ENVIRONMENTAL EVALUATION GROUP

December 31, 1997

Mr. Frank Marcinowski
Radiation Protection Division
Office of Radiation and Indoor Air
U.S. Environmental Protection Agency
401 M Street SW
Washington, DC 20460

SUMMARIES OF THE ISSUES PRESENTED ON 12/10/97

Figure 1. CCDF Overall Mean for Solubility Modeling with the CCA, Nesquehonite, and 'No Backfill' Values.

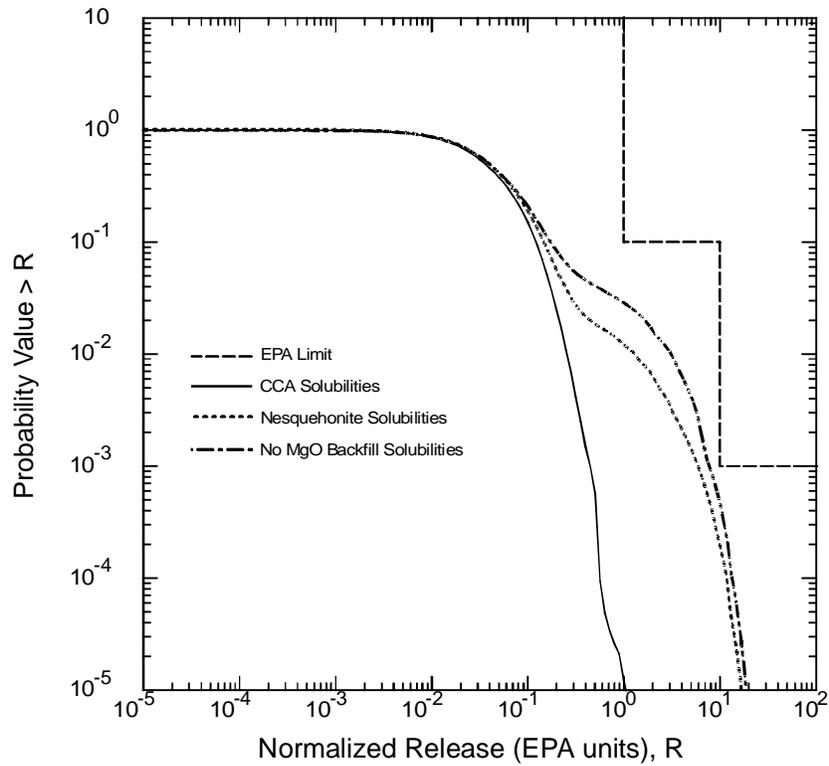
Lastly, the PANEL files were incorporated into the CCDFGF to create CCDF curves for comparison with 40 CFR Part 194. In addition to the Nesquehonite and No Backfill simulations with PANEL to create the new CCDFs, the CCA PANEL files containing CCA solubilities were used with PAVT releases of direct brine release, cuttings, spallings, and transport through the Culebra. Figure 1 shows the CCDF results of the different solubilities.

The figure shows that none of the curves violate the standard. The CCA solubility model has an estimated release of 0.45 EPA units at the 10^{-3} probability level. This is slightly higher than the 0.37 EPA units of the PAVT model and 0.22 EPA units of the CCA. The releases are shown to increase to 6 EPA units for Nesquehonite solubilities and to 7.5 EPA units for ‘No Backfill’ solubilities. The EPA compliance limit for the 10^{-3} probability level is 10 EPA units, or 3500 Ci for Plutonium, Uranium, Thorium, and Americium.

The EEG therefore recommends that the EPA reexamine these issues and provide additional justification for the CCA and the PAVT solubility values. If convincing justification is not available, then the "no backfill", or "nesquehonite" solubilities should be used in a new performance assessment calculation.

Figure 2: Cumulative Net Brine in and outflow at Repository, FEP S-1 Analysis From Vaughn et al, 1996.

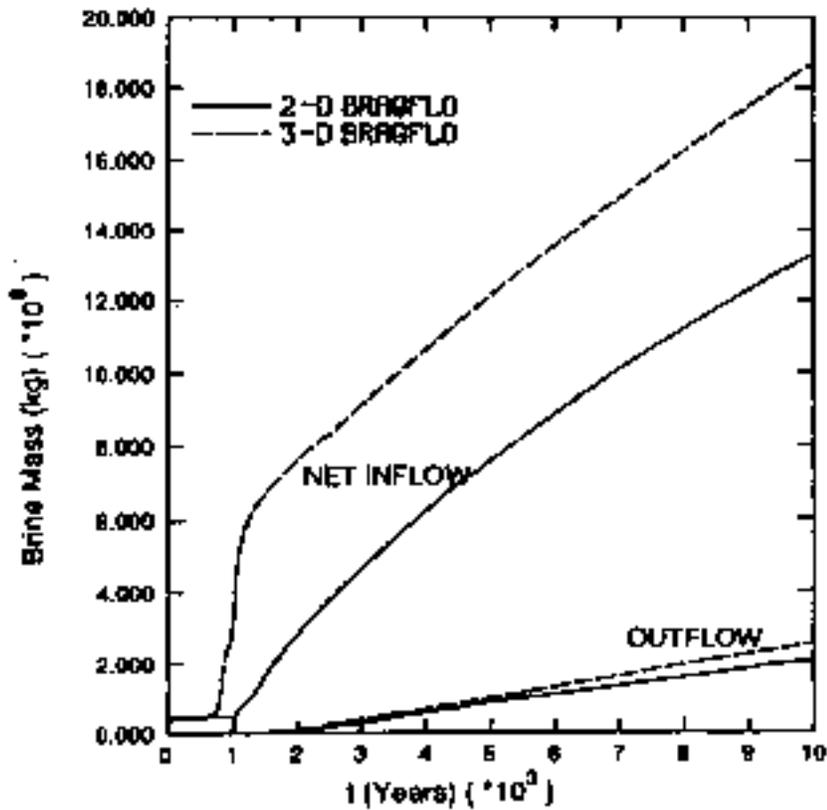
Figure 2 depicts the calculated brine inflow and outflow rates. The figure shows a large difference in calculated inflows of the two models during the period of 700 to 1,000 years. Figure 3 reinforces the perception that the brine inflow in the 3-D model is large. As shown in Figure 3, during the 700 to 1,000 years period the 3-D model shows a decrease in gas saturation of 0.05. Our concern is that if the brine inflow calculated in the 3-D model persists for thousands of years then the 2-D model calculations significantly under-predict repository saturation at high pressures.

Figure 15 of the FEP S-1 analysis (Figure 2) shows the cumulative brine inflow to the repository for the high gas generation calculations. The flows calculated using the 3-D model indicate that once anhydrite bed fracturing occurs roughly 2×10^6 kg ($1,600 \text{ m}^3$) of brine enters the repository in a period of 200 to 300 years and that this flow rate was continuing unabated at the time of drilling intrusion. Another 4×10^6 kg ($3,200 \text{ m}^3$) flowed into the repository shortly after the drilling intrusion. Figure 2 shows differences of 4×10^6 to 6×10^6 kg ($3,200$ to $6,500 \text{ m}^3$) for much of the 10,000 years. The brine inflow differences listed above should be doubled for the full repository. Virtually no flow enters the repository as a result of anhydrite bed fracturing in the 2-D geometry. In fact, the net flow over the 10,000 year simulation is less with anhydrite fracturing compared the simulation without the beds fracturing. Figure 2.1.4 of the sensitivity analysis report² (Figure 3) indicates very little marker bed inflow with microbial gas generation of plastics and

Figure 4: Three dimensional scatter plots for volume of brine reaching the surface due to direct brine release for a drilling intrusion into the lower panel. From Helton, 1996.

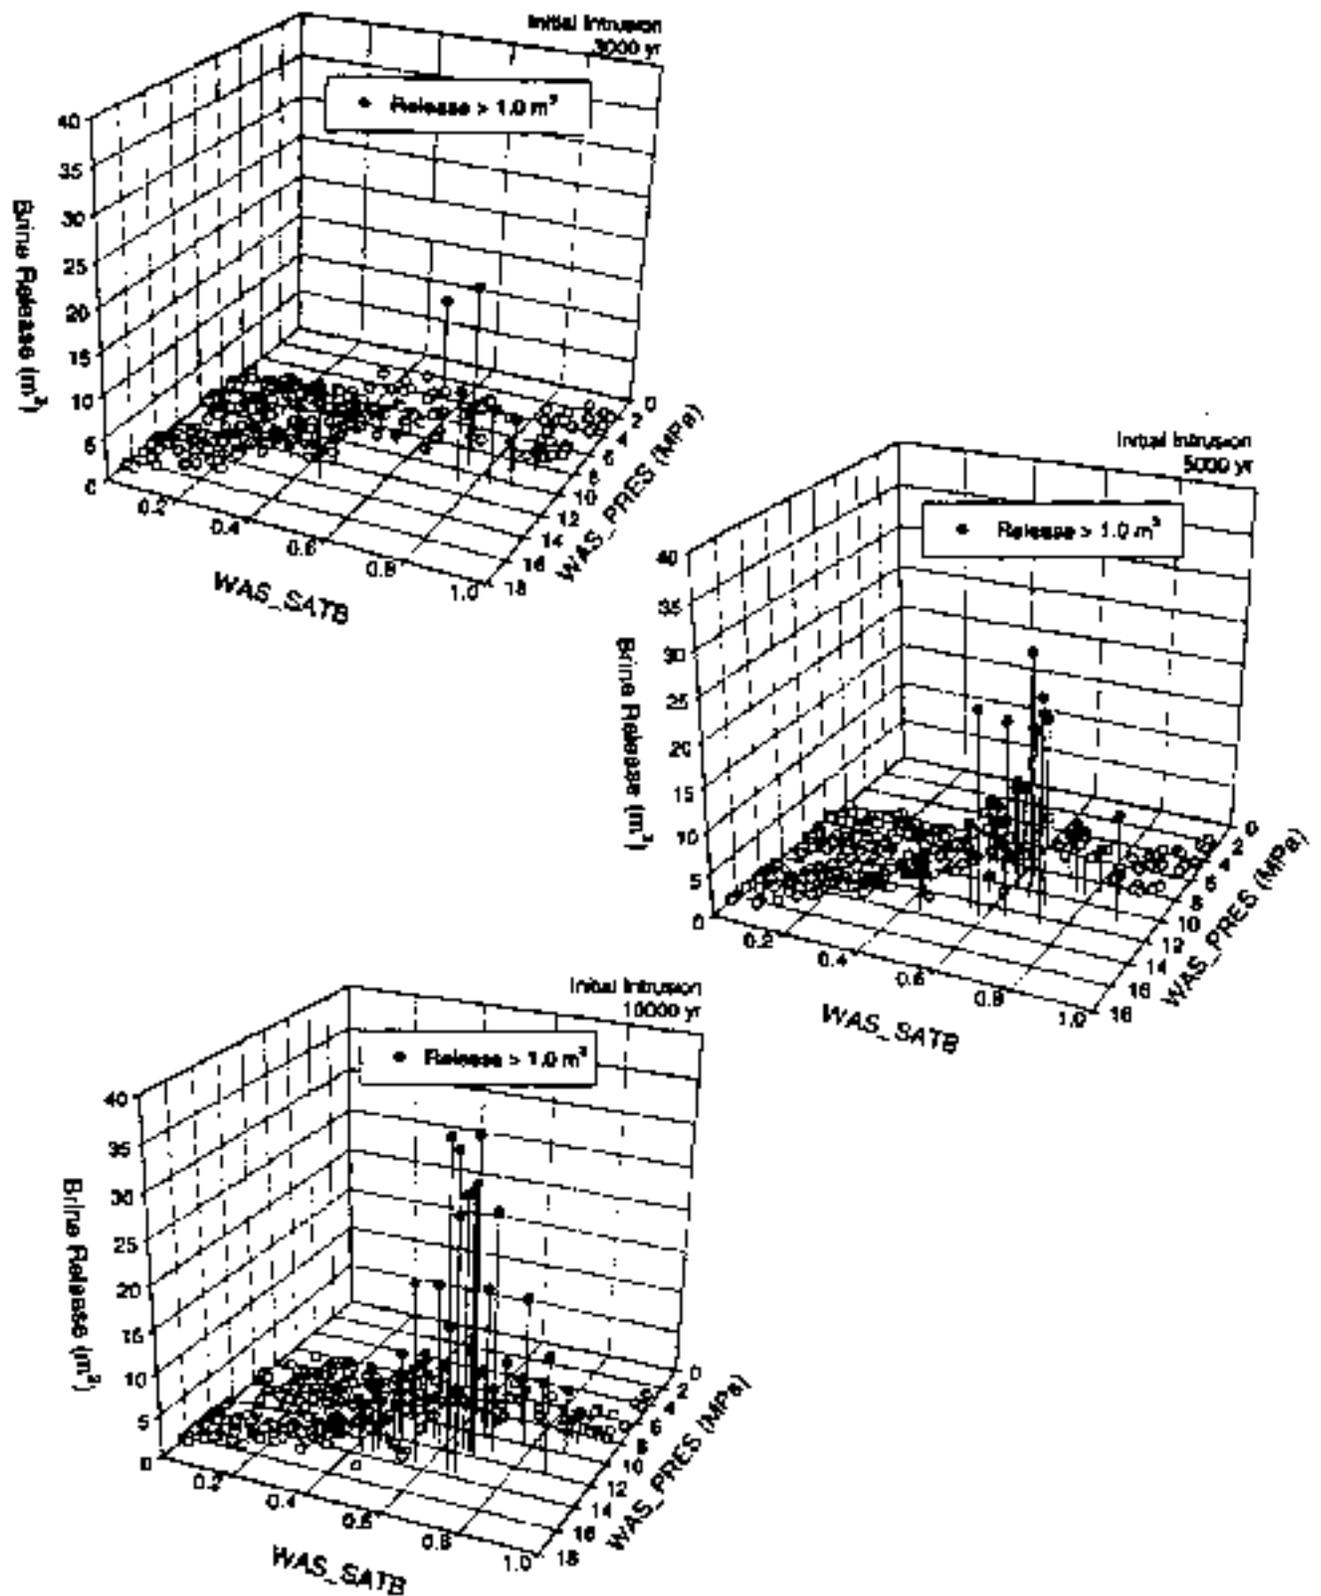
Greater saturations could lead to much larger direct brine release calculations. Figure 4 (Figure 5.1.5 of *Helton*) is the basis of this contention. Figure 4 depicts the relationship of calculated direct brine releases to repository conditions at three separate times. The average repository brine saturation and repository pressure are plotted for each vector on the horizontal plane. A vertical line connects the plane to a small circle at the level of the vertical axis corresponding to the volume of brine calculated to reach the surface. Calculated releases greater than one cubic meter are highlighted using a filled circle.

Figure 4 indicates that there were few calculated direct brine releases when the calculated repository pressures exceeded 12.7 MPa and almost none when the pressure exceeded 14 MPa. Almost all of the larger calculated direct brine releases occurred when brine saturations were above 0.5, a condition never calculated at pressures above 14 MPa. The FEP S-1 analysis suggests that the potential for many of the vectors with great repository pressure to also have large brine saturations. Thus calculated direct brine releases might have both larger volumes and greater frequency in the performance assessment.

Either greater pressures or saturations could lead to much larger direct brine release calculations. Figure 4 indicates that there were very few calculated direct brine releases when the calculated repository pressures exceeded 12.7 MPa and almost none when the pressure exceeded 14 MPa. Almost all of the larger calculated direct brine releases occurred when brine saturations were above 0.5, a condition never calculated at pressures above 14 MPa. The FEP S-1 analysis suggests that the potential for many of the vectors with great repository pressure to also have large brine saturations. Thus calculated direct brine releases might have both larger volumes and greater frequency in the performance assessment.

Consider Figure 4. This figure provides a plot of calculated brine saturation and pressure conditions in the repository at three separate times for undisturbed performance. This figure shows a correlation of brine saturation with repository pressure. There are at least three mechanisms that may lead to such a correlation:

Figure 5: Fraction of Initial Iron Remaining in Repository
From: DOE, 1996.

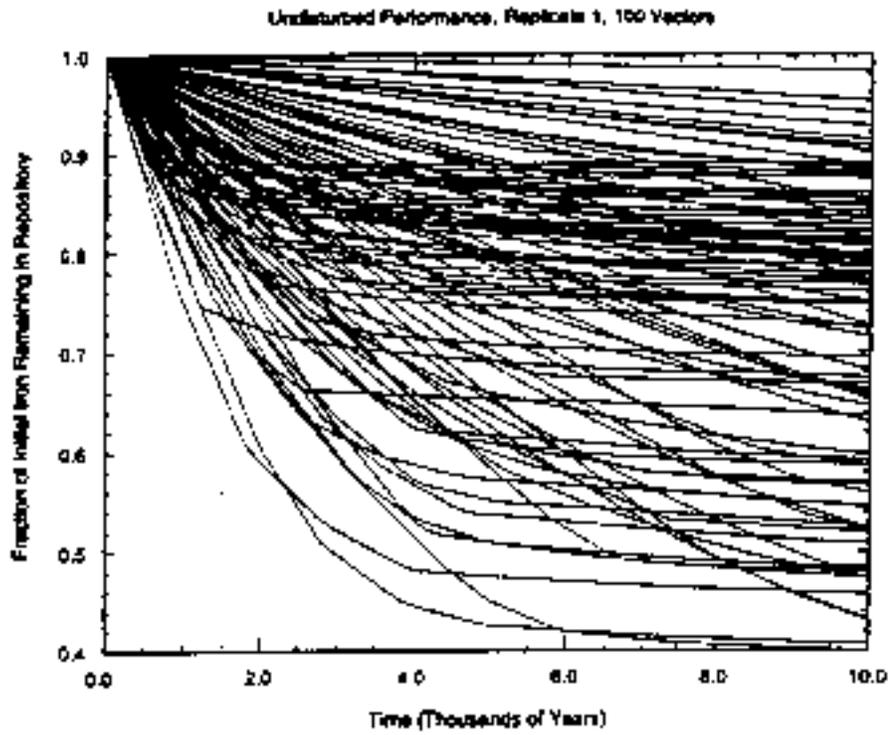
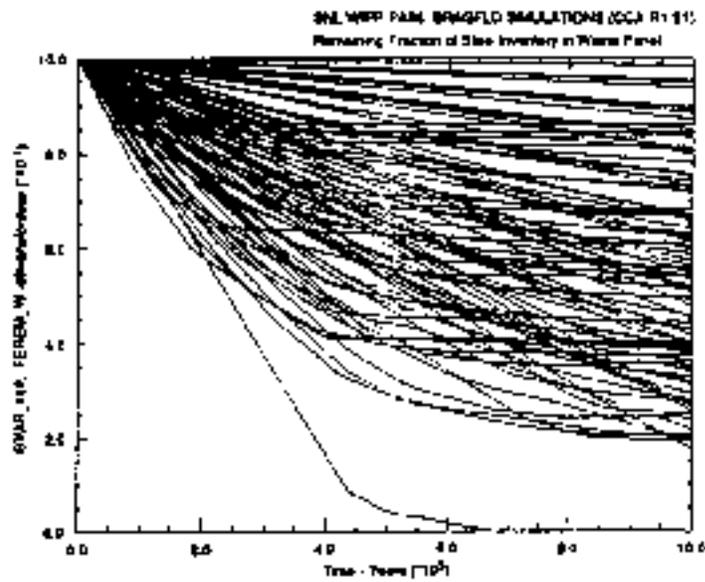
The DOE cites the amount of iron remaining in the repository (Figure 5; *DOE*, 1996 Figure 12-13) as support for the argument that more brine inflow will lead to more gas generation not higher saturations. Figure 6 (Figure 2.2.9 of *Helton*) shows less iron remaining

in the lower (waste) panel, presumably due to relatively more brine inflow to the lower panel (Pg 2-18 of Helton, 1996). Figure 7 (Figure 2.2.7 of Helton, 1996) shows that at most 30,000 cubic meters of brine are predicted to be consumed through iron corrosion. In most vectors, the calculated brine consumption was less than 15,000 m³. In many, brine consumption continues through-out the 10,000 year compliance period. Other vectors show a secession of brine consumption after less than 2,000 years, presumably due to exhaustion of available brine (See Section 2.2 of Helton). Figure 2 suggests that brine inflow from fracturing may be on the order of 10 m³ / year or more and continue for hundreds to thousands of years. Drawn on the Figure 7 is a line with a slope of 10 m³ / year. Comparing the brine consumption with this slope indicates that the potential brine flow is large compared to the rate of brine consumption. The potential brine inflow is greater than 10,000 m³. Most of this flow would likely be into the lower panel. The maximum amount of brine consumed in the lower panel was 6,000 m³ (Figure 8, Figure 7.2.1-10 of Bean et al.).

Figure 9: Percentile curves for three replicated LHSs for pressure in waste panel
From: Helton, 1996.

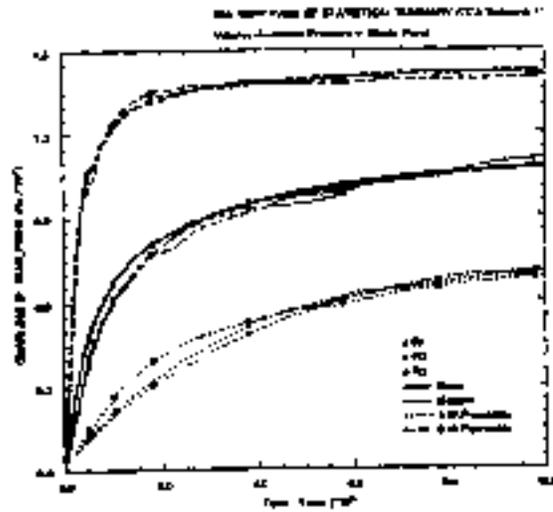
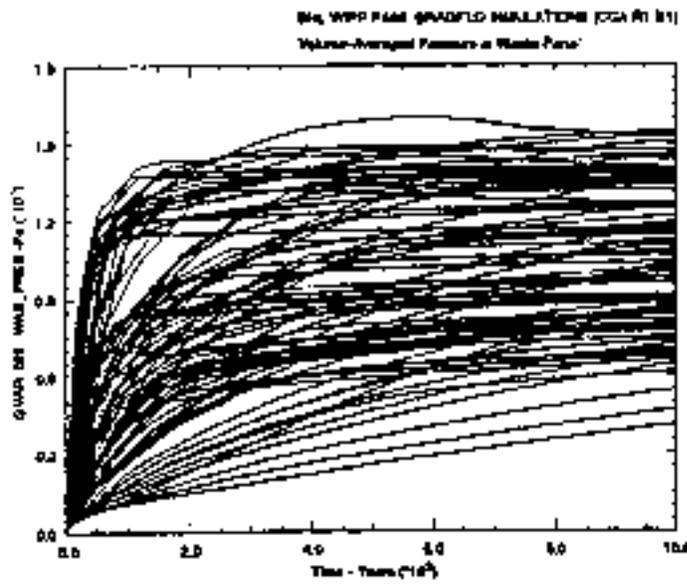
DOE cites Figure 9 (Figure 2.3.2 of Helton), showing the 10, 50 and 90 percentile pressures for each replicate for the 10,000 years, as demonstration that pressures will not increase greatly above 12.7 MPa. In fact, Figure 10 (Figure 2.3.1 of Helton), which depicts the pressure history of each vector of replicate 1, indicates that many of the calculated pressures were greater than 13 MPa and that for one vector the calculated pressure reached close to 16 MPa. 16 MPa is less than 2 MPa below the 17.5 MPa peak pressure of the 2-D simulation of the FEP S-1 analysis (Figure 1). The DOE has offered no explanation of what happens between 16 and 17.5 MPa to cause such large brine inflow in the 3-D simulation but not the 2-D simulation. A believable explanation is that the change occurs at initiation of anhydrite fracturing not just above 16 MPa.

Figure 11: Mean CCDFs for Specific Release Modes, Replicate 1.
From DOE, 1996.

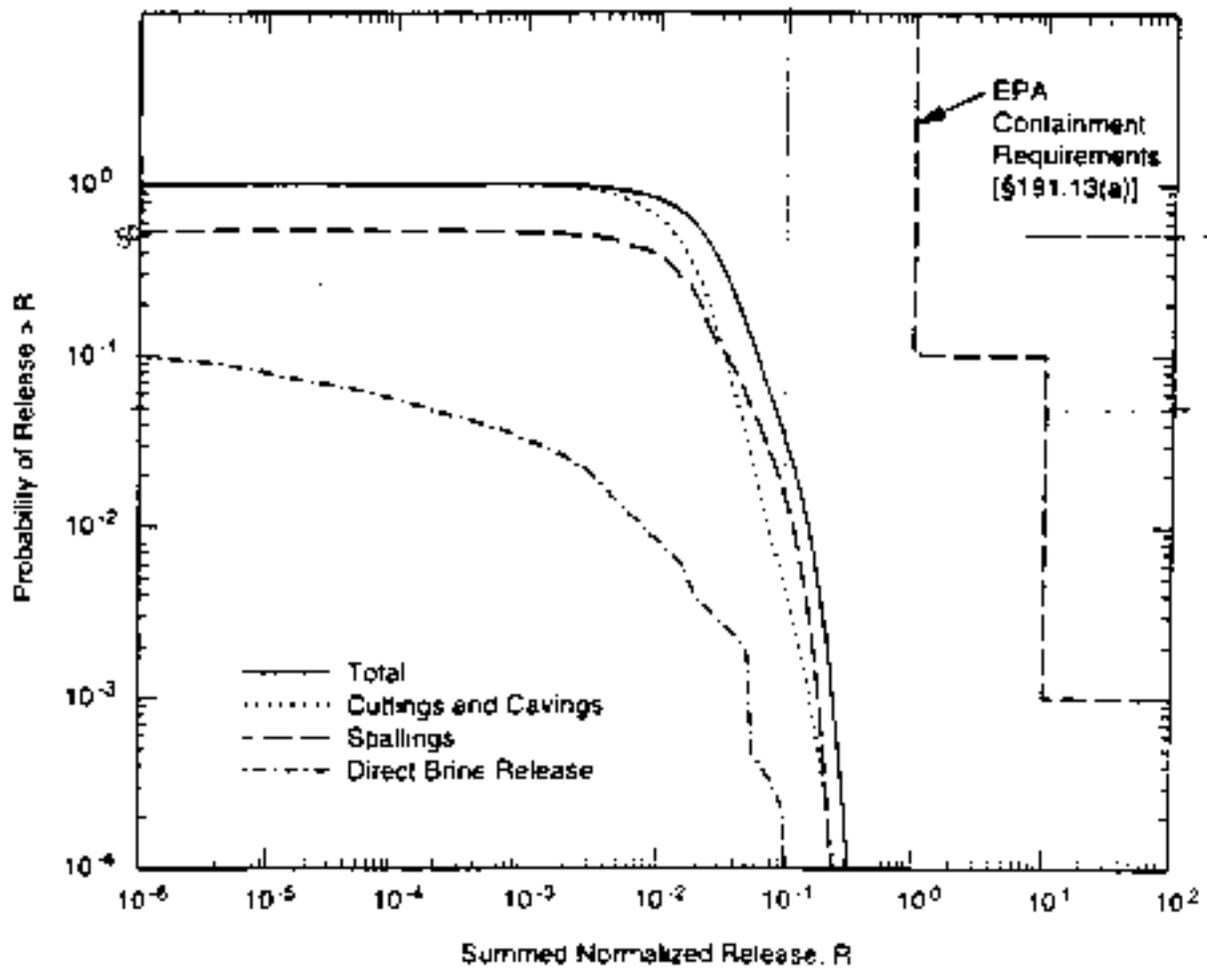
Direct brine release was a minor component of the total calculated radionuclide releases in the CCA (Figure 11; Figure 6-41 of the CCA). The volumes of direct brine release would have to be two orders of magnitude greater to have an impact on agreement with the containment requirements which is large in relation to a possible increases in the calculated volumes of brine brought to the surface through direct brine release. However, the radionuclide content of brine brought to the surface may be underestimated in the CCA which would make direct brine release of greater significance to the performance assessment (See EEG comments on solubility).

Figure 12: Scatter Plots of the Fraction of Iron Remaining in the Waste Panel (Right Frames) and Rest of the Repository (Left Frames) for Undisturbed Conditions at 10,000 Years. From Helton, 1996.

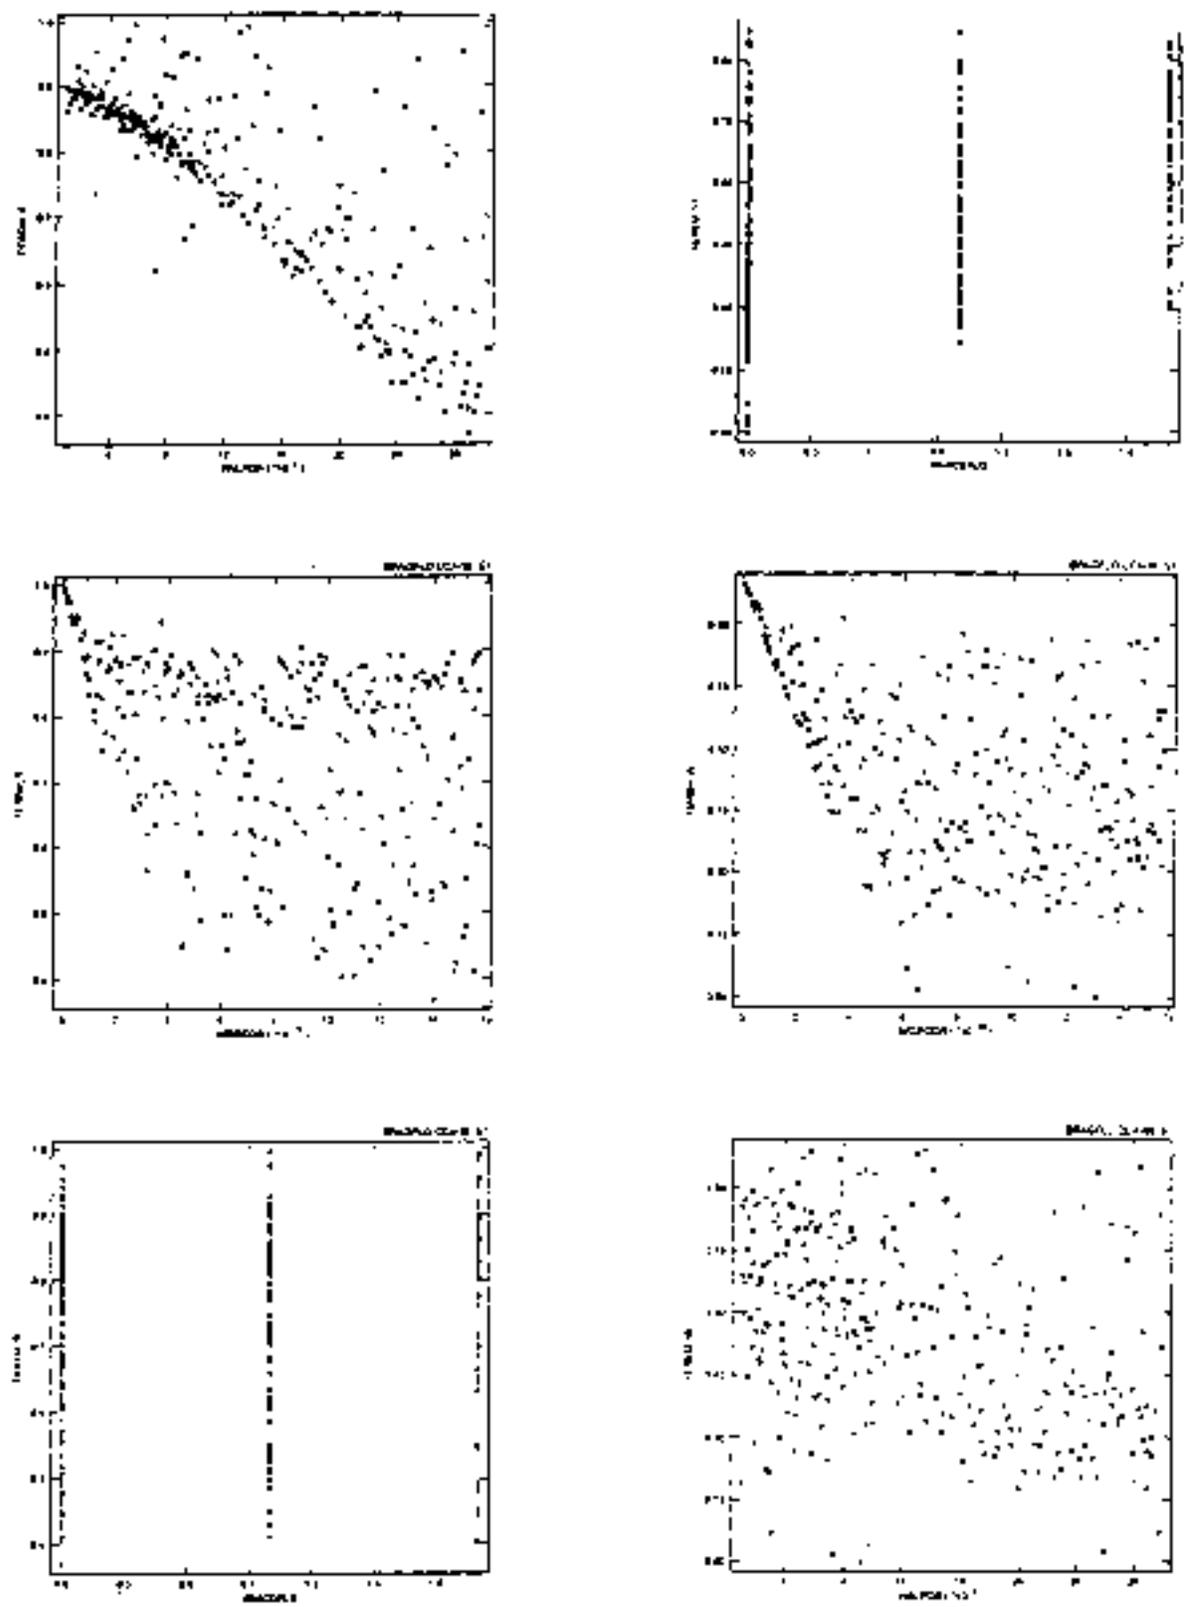
Figure 12 (Figure 2.4.3 of *Helton*) provides important supporting evidence. The figure presents the fraction of iron remaining in the lower waste panel (FEREM_W) or in the rest of the repository (FEREM_R) with respect to halite porosity, microbial degradation, steel corrosion rate. The plots of remaining iron and halite porosity suggest that a sufficient supply of brine is needed for iron consumption but other factors also limit corrosion. The main factor is probably corrosion rate. Figure 12 shows that low corrosion rates limit iron consumption, but that predicted iron consumption is not strongly dependent on corrosion rate. The comparison of iron remaining to microbial degradation is important because its strong correlation with repository pressure (Table 1). These plots show that the fraction of iron remaining in the repository is only weakly correlated with microbial degradation and that the correlation is positive e.g. microbial degradation, hence pressure, is inversely correlated with iron consumption. This inverse correlation is probably linked to the availability of brine.
